SERVICE BULLETIN No. 292 72 2222

Version: B

**Reason for update:
Modification to the list of parts**

**Subject:
Module M02 (Compressor) - Replacement of the equipped jet.
Modification TU 222.**

Equipped casing assembly
Figure 1

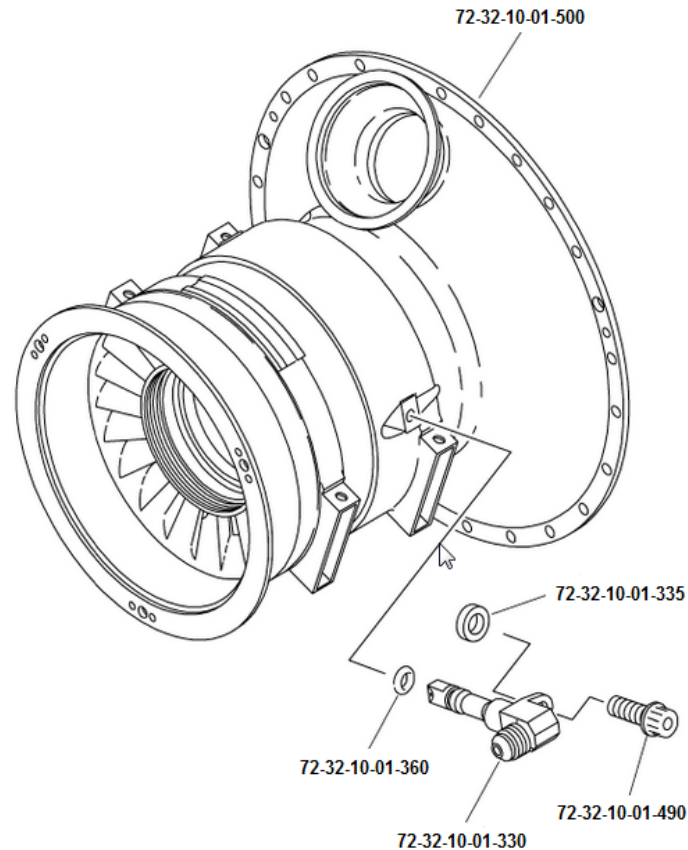
2.6.2.2. Removal of the PRE TU 222 equipped jet (72-32-10-01-330) of the compressor casing (72-32-10-01-500)

- 2.6.2.2.1. Remove the screw (72-32-10-01-490) that attaches the equipped jet.
- 2.6.2.2.2. Remove and discard the equipped jet (72-32-10-01-330).
- 2.6.2.2.3. Remove and discard the adjusting washer (72-32-10-01-340).
- 2.6.2.2.4. Remove and discard the preformed packing (72-32-10-01-360) from the equipped jet.

2.6.2.3. Installation of the POST TU 222 equipped jet (72-32-10-01-330)

- 2.6.2.3.1. Lubricate a new preformed packing (72-32-10-01-360).
- 2.6.2.3.2. Install a new preformed packing (72-32-10-01-360) on the equipped jet (72-32-10-01-330).
- 2.6.2.3.3. Put the equipped jet (72-32-10-01-330) in position in its housing in the casing (72-32-10-01-500).
- 2.6.2.3.4. Put the washer between the casing (72-32-10-01-500) and the equipped jet (72-32-10-01-330).
- 2.6.2.3.5. Install the screw (72-32-10-01-490) through the equipped jet (72-32-10-01-330) and the washer (72-32-10-01-335).
- 2.6.2.3.6. Tighten the screw (72-32-10-01-490) that attaches the equipped jet (72-32-10-01-330) to the apparent torque of 4.8 N.m.

Equipped casing assembly

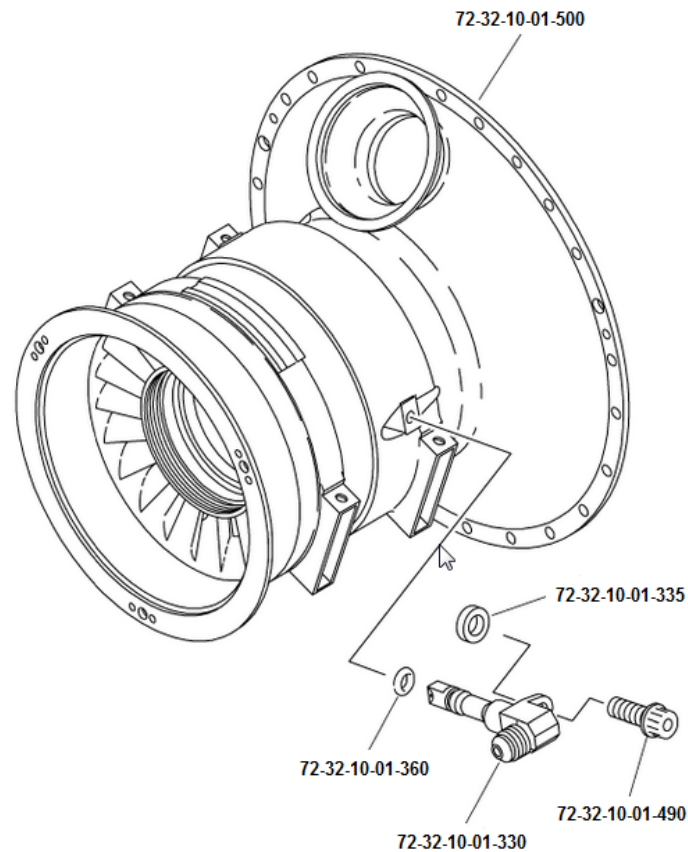
4.6.2. Operating instructions**4.6.2.1. Removal of the PRE TU 222 equipped jet**

4.6.2.1.1. Remove the screw (72-32-10-01-490).

4.6.2.1.2. Remove and discard the equipped jet (72-32-10-01-330).

4.6.2.1.3. Remove and discard the washer (72-32-10-01-340).

4.6.2.1.4. Remove and discard the preformed packing (72-32-10-01-360).

4.6.2.2. Installation of the POST TU 222 equipped jet

4.6.2.2.1. Lubricate a new preformed packing (72-32-10-01-360).

4.6.2.2.2. Install a preformed packing (72-32-10-01-360) on the equipped jet (72-32-10-01-330).

4.6.2.2.3. Install the equipped jet (72-32-10-01-330) on the compressor casing (72-32-10-01-500).

4.6.2.2.4. Put the washer (72-32-10-01-335) in position between the compressor casing (72-32-10-01-500) and the equipped jet (72-32-10-01-330).

4.6.2.2.5. Tighten the screw (72-32-10-01-490) to the standard torque: Refer to the Common Techniques Book, task 70-50-20-350-801.
